Battelle South Development

Stormwater Drainage Manual Type 2 and 3 Variance Application COMMENTS (dated 7/13/17 draft)

Battelle South 100 year floodplain (FEMA FIRM)

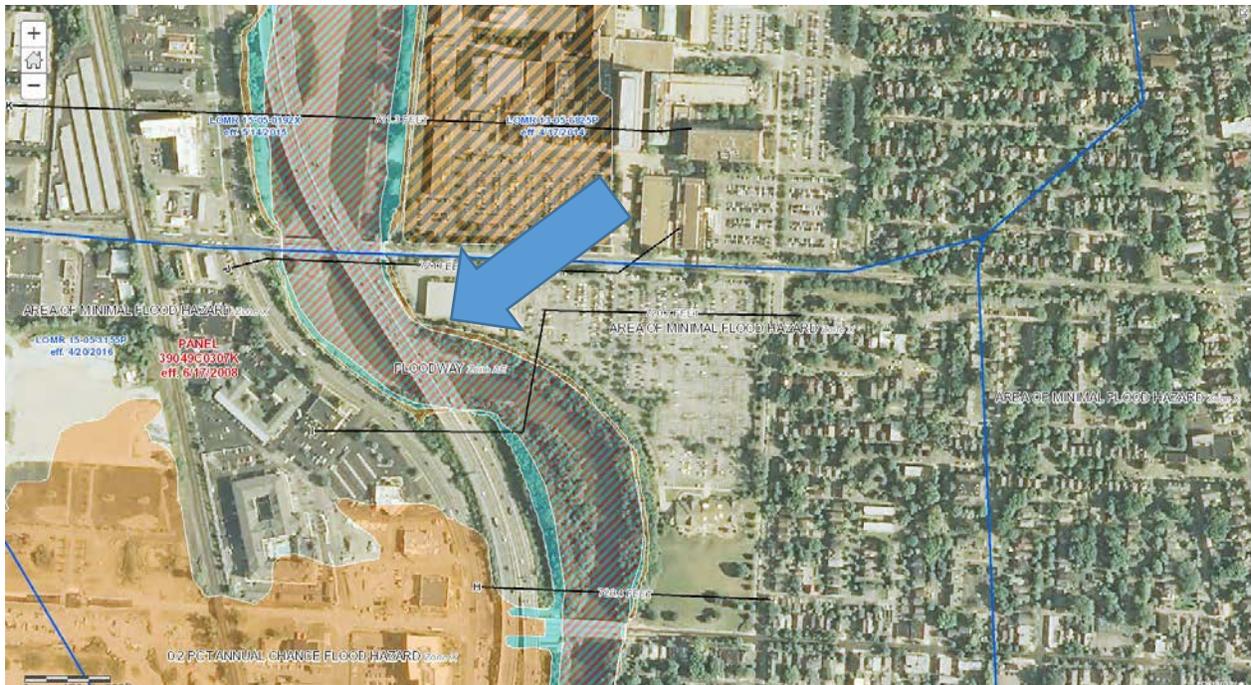
3. Will there be impacts to the 100 year floodplain in the northern portion of the parcel shown by the light brown?
4. FLOW requests that the applicant consider installing Green Roofs on the new buildings to help slow the flow of rainwater reaching the Olentangy. Or consider bio-retention. Is the applicant aware of the Stormwater Credit Manual and the potential reduction in stormwater fees?
